## 9. RECOMMENDED REMEDIATION WORKS

**Stan Giaouris**  
B.Build  
**Building Consultant**

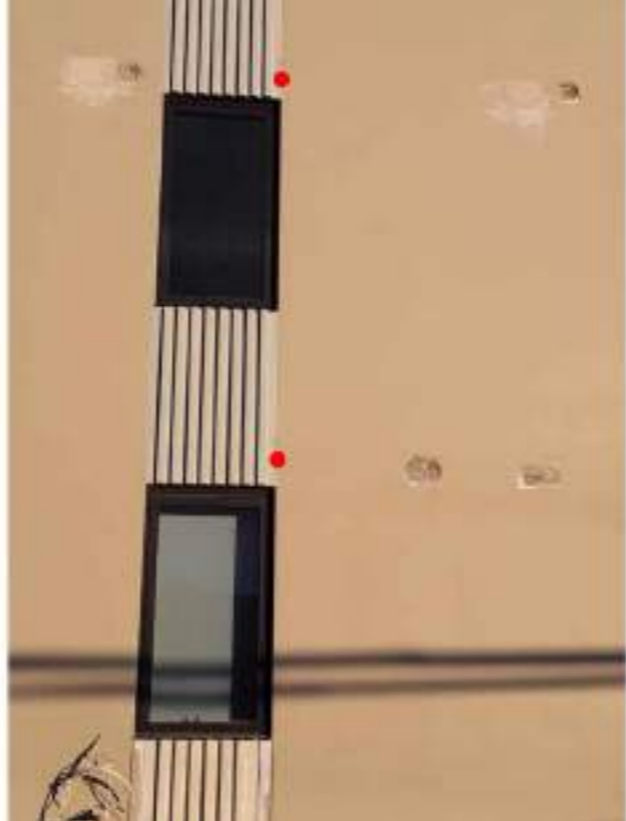
DEFECT NO.	LOCATION	AREA	BREACH	PHOTOGRAPH	DEFECT DESCRIPTION
C 7	Ground floor south entry	Hebel cladding	See section 8.26 of this report.		No pressure equalisation slots have been installed.
<b>Common area (toilet)</b>					
C 8	Common area	Toilet ceiling	See section 8.14 of this report.		Ceiling height is 2080mm.

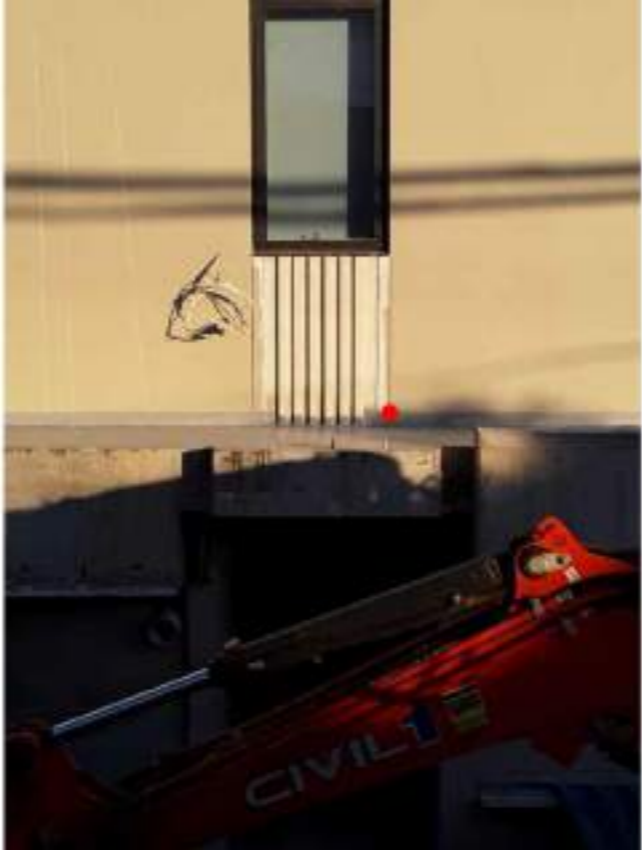
DEFECT NO.	LOCATION	AREA	BREACH	PHOTOGRAPH	DEFECT DESCRIPTION
C 14	East facade	Hebel cladding	See section 8.26 of this report.		No visible pressure equalisation slots as required by Hebel manufacturer.
C 15	East facade	FC cladding	See section 8.5 and 8.6 of this report.		Base of FC sheets have been waterproofed up.

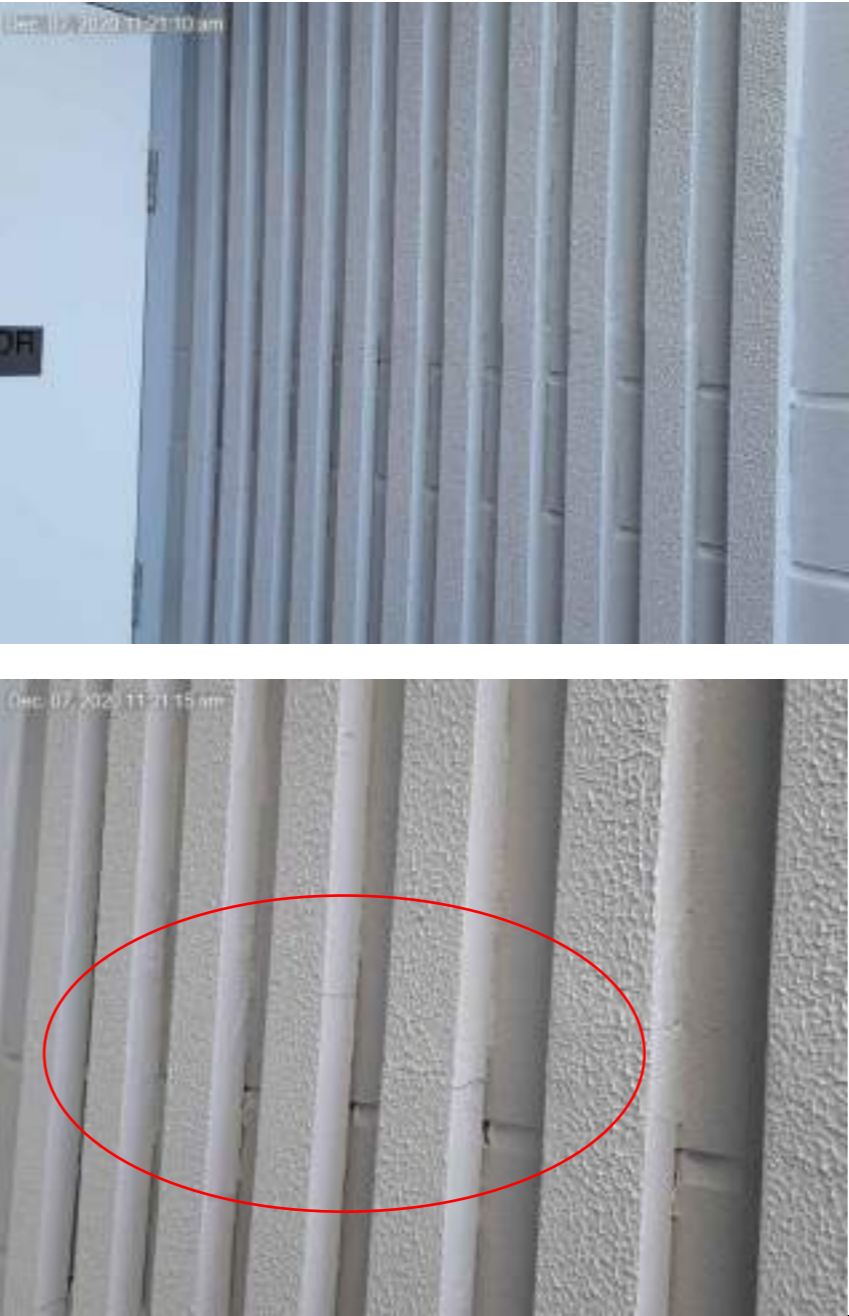
DEFECT NO.	LOCATION	AREA	BREACH	PHOTOGRAPH	DEFECT DESCRIPTION
C 18	East facade	Hebel cladding	See section 8.26 of this report.		The single drainage provision has been waterproofed over.
C 19	East facade	Hebel cladding	Note		Some drainage provisions were identified at the Property.

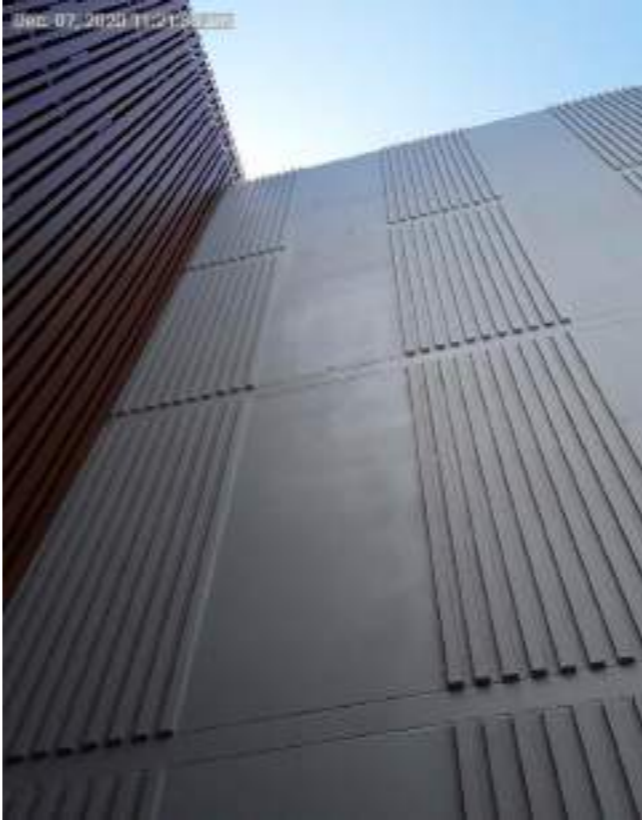
DEFECT NO.	LOCATION	AREA	BREACH	PHOTOGRAPH	DEFECT DESCRIPTION
C 21	East facade	Hebel cladding	Works have not been completed with due care and skill.		Weepholes have been partly covered.
C 22	East facade	Hebel cladding	See section 8.26 of this report.		Drainage provisions are partly covered throughout the facade.

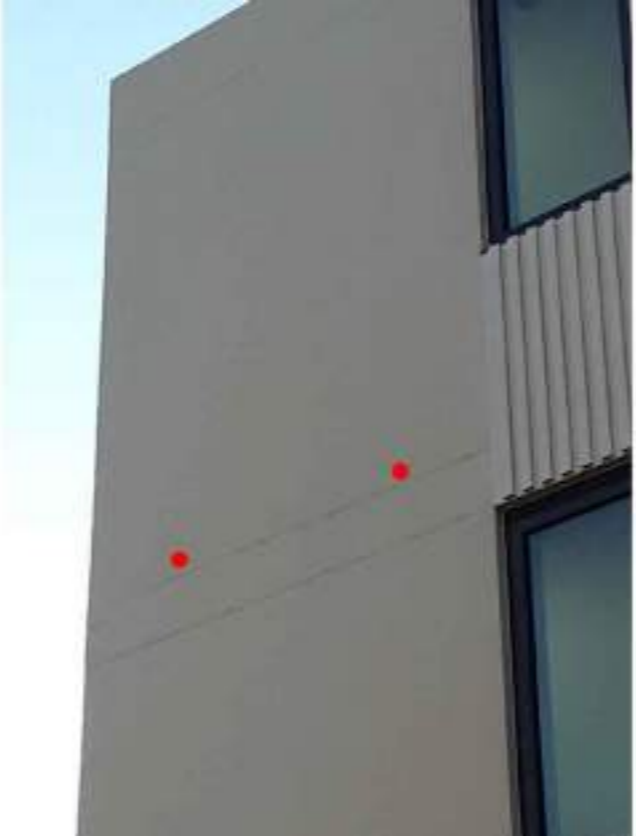
DEFECT NO.	LOCATION	AREA	BREACH	PHOTOGRAPH	DEFECT DESCRIPTION
C 27	East facade	Balcony slab edge	See section 8.9 of this report.	 <p>Dec. 07, 2020 11:25:34 am</p>	Efflorescence.
C 28	East facade	Balcony slab edge	See section 8.9 of this report	 <p>Dec. 07, 2020 11:25:41 am</p>	Efflorescence.

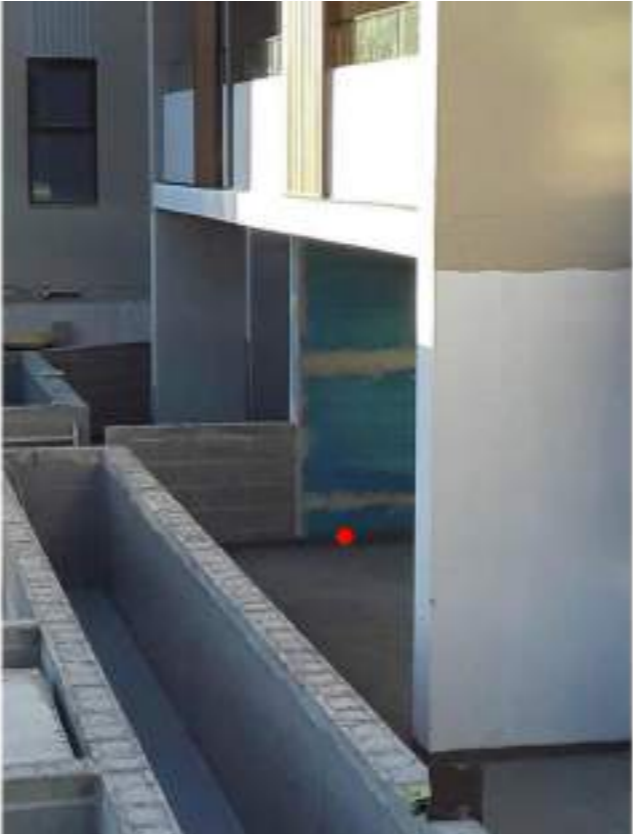
DEFECT NO.	LOCATION	AREA	BREACH	PHOTOGRAPH	DEFECT DESCRIPTION
C 31	West facade	Units balcony	See sections 8.3 and 8.5 of this report.		Red – FC installed below water level. Blue - set down height once tiled will not be compliant with AS4654.2.
C 32	West facade	Hebel cladding	See section 8.26 of this report.		Missing drainage provisions to Hebel.

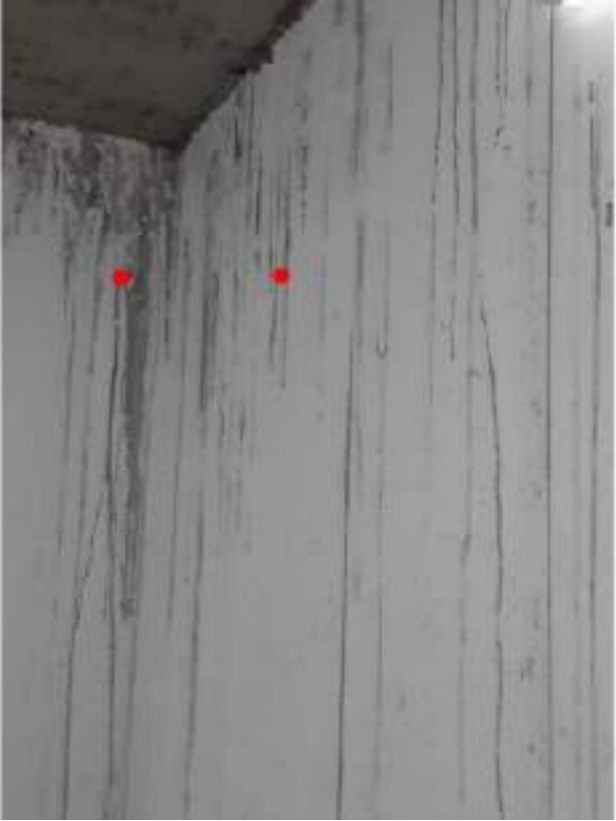
DEFECT NO.	LOCATION	AREA	BREACH	PHOTOGRAPH	DEFECT DESCRIPTION
C 51	South Facade (Mitchell Avenue)	Balcony slab edge	See section 8.9 of this report.		Efflorescence in this location is the result of failed waterproof membrane upturn.
<b>Basement Stair</b>					
C 52	Basement 1	South east fire stair to ground level	See section 8.15 of this report.		Missing nosing or compliant non-slip finish to steps.

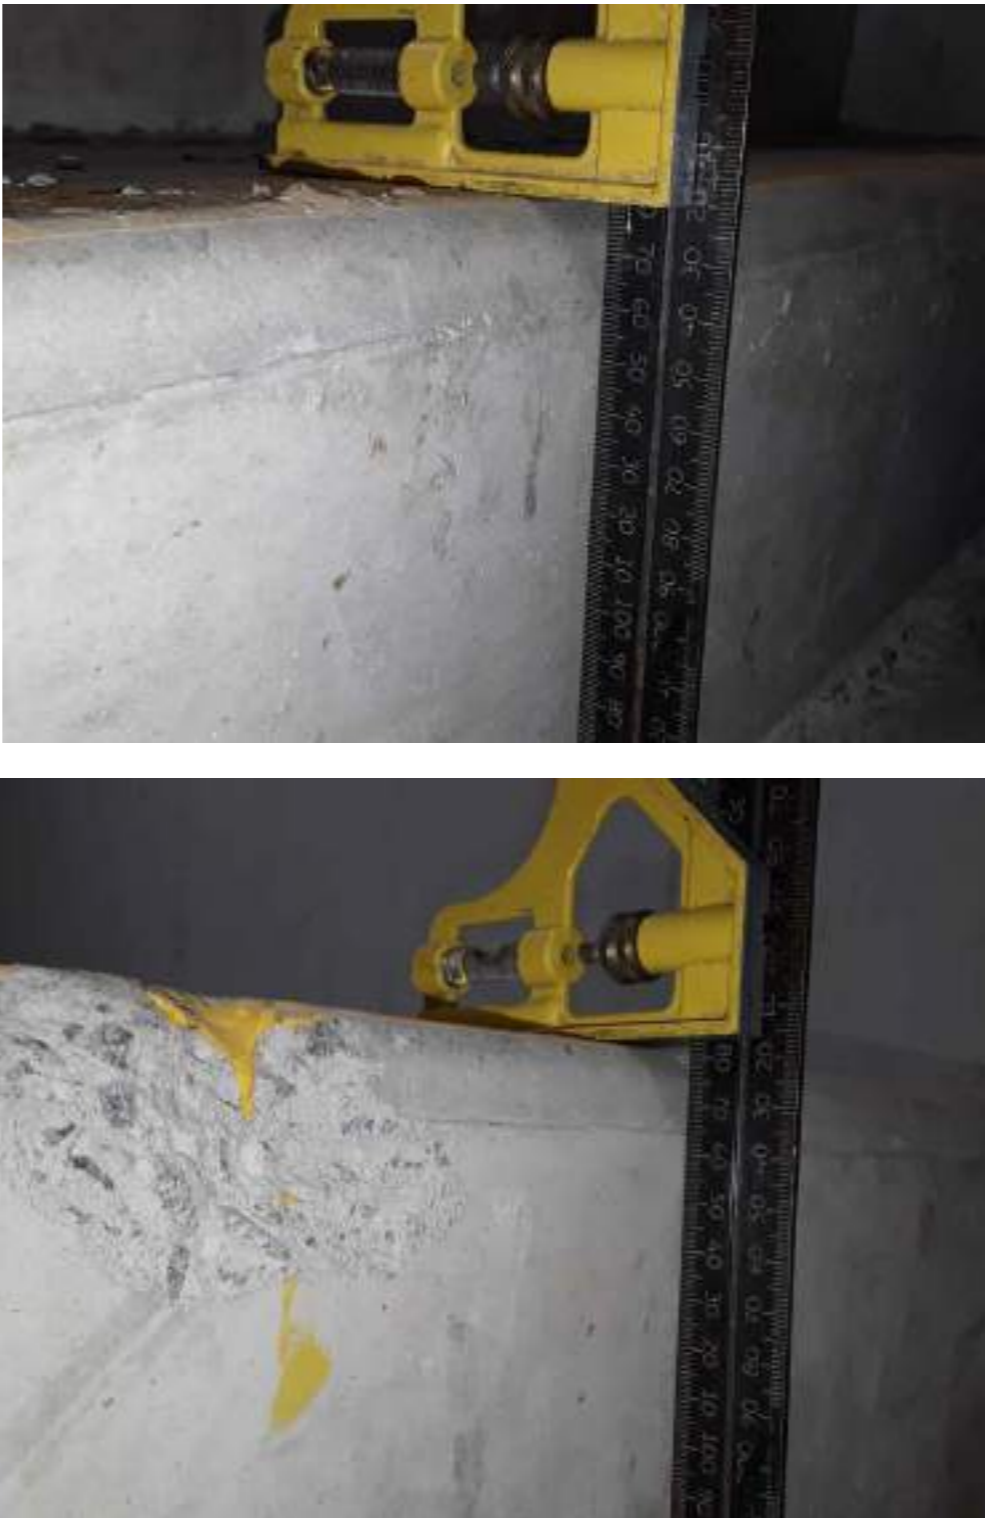
DEFECT NO.	LOCATION	AREA	BREACH	PHOTOGRAPH	DEFECT DESCRIPTION
C 57	Basement 1	South east fire stair to ground level	See section 8.15 of this report.		<p>No nosing or non-slip finish.</p> <p>Details of paint to be provided to identify if non-compliant and tested to AS4586.</p>
C 58	Basement 1	South east fire stair to ground level	Works have not been completed with due care and skill.		<p>Visible patching and slurry over pour from construction.</p>

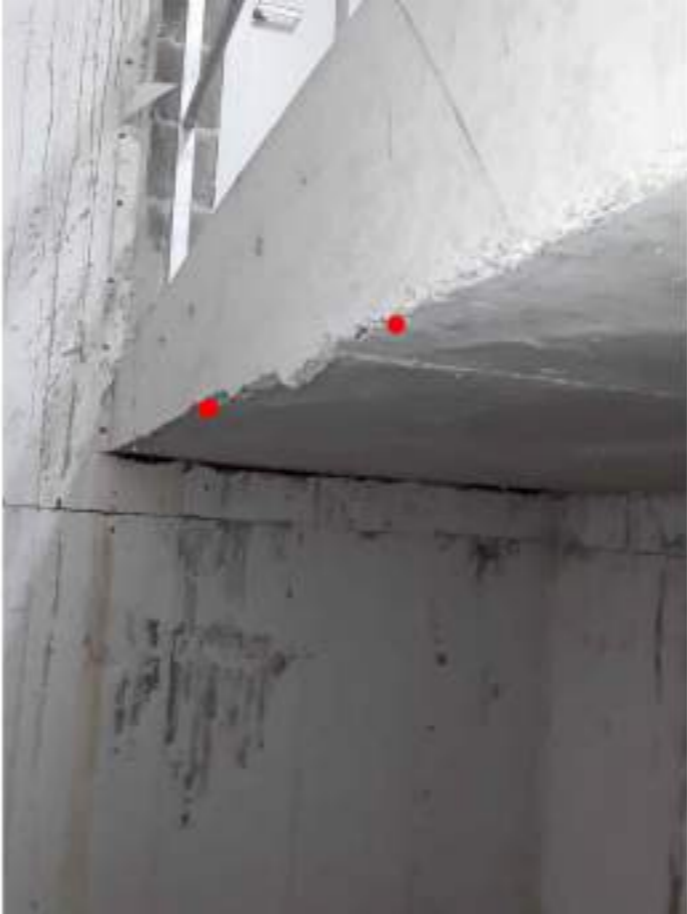
DEFECT NO.	LOCATION	AREA	BREACH	PHOTOGRAPH	DEFECT DESCRIPTION
C 59	Basement 1	South east fire stair to ground level	Works have not been completed with due care and skill.		Sensor temporarily installed.
C 60	Basement 1	South east fire stair to ground level	See section 8.15 of this report.		No nosing or non-slip finish.  Details of paint to be provided to identify if non-compliant and tested to AS4586.

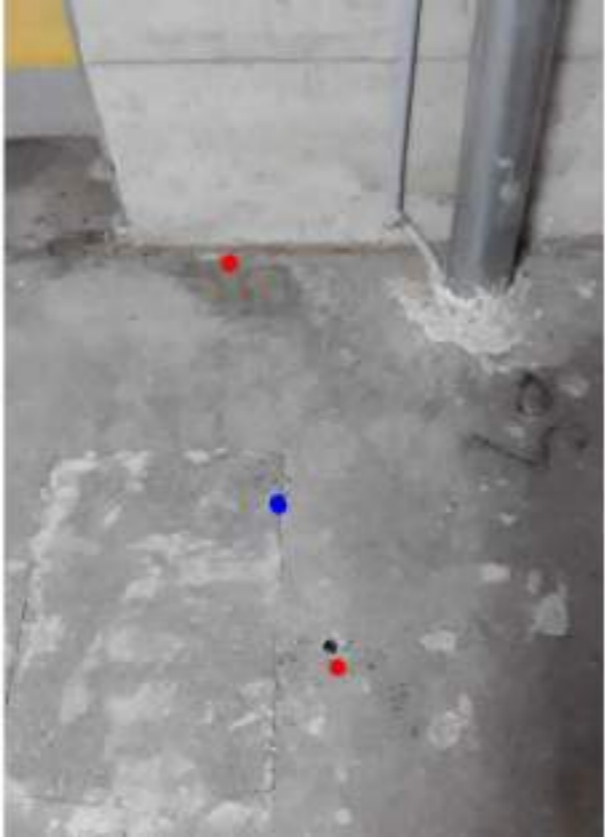
C 104	Basement 1	South	Works have not been completed with due care and skill.		Nails retained throughout soffit.

C 104	Basement 1	South	Nails retained throughout soffit.	Remove and patch with render.
C 105	Basement 1	South-east corner	Incomplete hydraulic work to the southeast corner and incomplete concreting.	
C 106	B1 and B2 ramp	Adjacent store	Nails retained in a store adjacent to B1 to B2 ramp.	Remove and patch with render.
C 108	Basement 1	Exist	The hump at lift exit.	Scabble hump and install screed.
C 109.A	Basement 1	Exist	Open conduit.	Electrician to cap off.
C 109.B	Basement 1	Exist	Formwork retained in the concrete.	Remove formwork.
C 109.C	Basement 1	Exist	Concrete patch not completed with due care and skill.	Remove and replace.
C 110.A	Basement 1	North-east floor waste	Duct tape to concrete.	Remove tape.
C 110.B	Basement 1	North-east floor waste	Concrete around the drain has not been completed with due care and skill.	Remove concrete and tape Install non-shrink grout.
C 112	Basement 1	Parking bay 2	Formwork retained to parking bay 2.	Remove formwork.

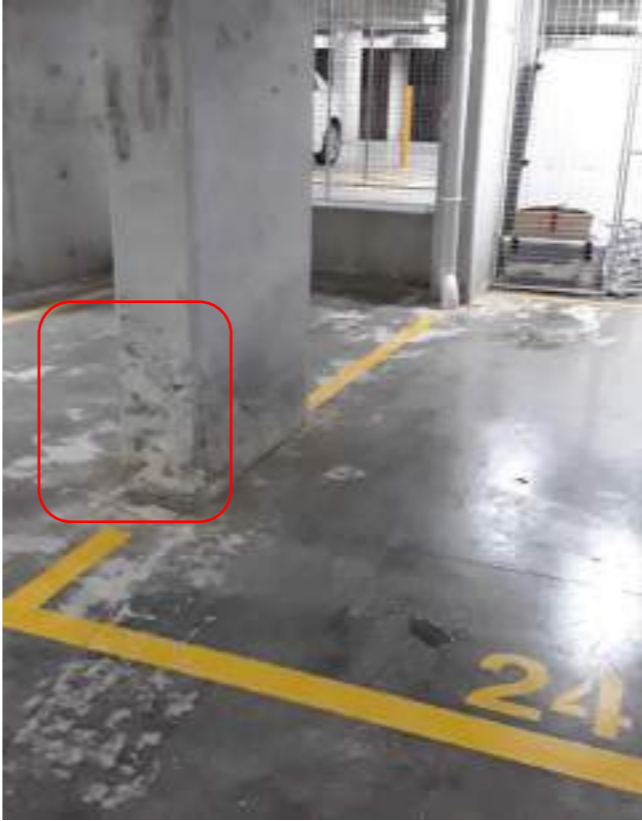
DEFECT NO.	LOCATION	AREA	BREACH	PHOTOGRAPH	DEFECT DESCRIPTION
C 117	Basement 2	North wall	See section 8.4 of this report.		Stagnant water behind parking bay 30.
C 118	Basement 2	North wall	See section 8.4 of this report.  Dish drain not draining as such not fit for purpose.		A. Saturated formwork to parking bay 30. B. Water ponding in dish drain.
